ADA Self Evaluation and Transition Plan

MiraCosta College, **Oceanside Campus**

Board Approved on 05-18-2017

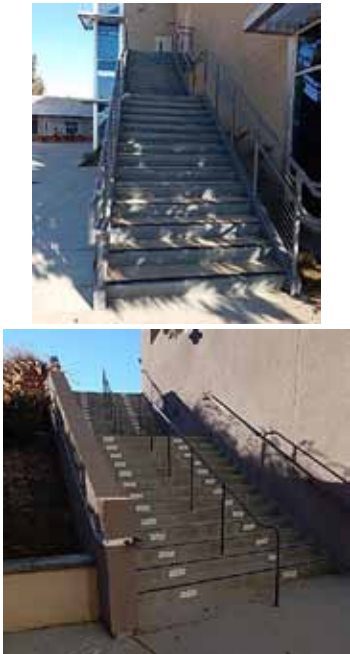
#	ITEM	PHOTO or DIAGRAM	MITIGATION MEASURE	SCHEDULE
C61	This wheelchair ramp at Building T110 is not compliant		Reconstruct this ramp so that it meets all of the requirements for the ramp and/or clearances as indicated in Appendix C.2, C.3, C.7, D.8	P2
C62	This wheelchair ramp at Building T100 is compliant.		None required.	N/A
C63	This wheelchair ramp at Building T110 is compliant.		None required.	N/A
C64	There is a flush condition at the end of this walkway leading into the vehicular way.		Provide a 36" deep band of DWD at the end of this walkway adjacent to the vehicular way according to Appendix A.13, A.14	P2

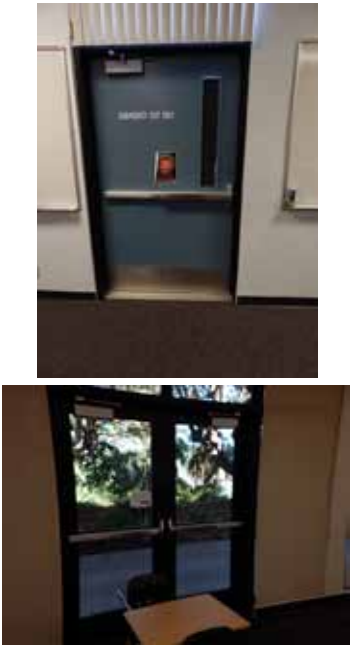
#	ITEM	PHOTO or DIAGRAM	MITIGATION MEASURE	SCHEDULE
D24.5	The interior POT of this facility is not compliant. The required signage is not provided		Install compliant signage according to appendix D.8	P2
D24.6	The interior of the conference room is compliant.		None required	N/A
D24.7	The sink in the meeting room is not compliant. The required knee and toe clearance is not provided.		Reconfigure this sink according to Appendix B.1	P2
D24.8	The interior of the employee work room is compliant.		None required	N/A
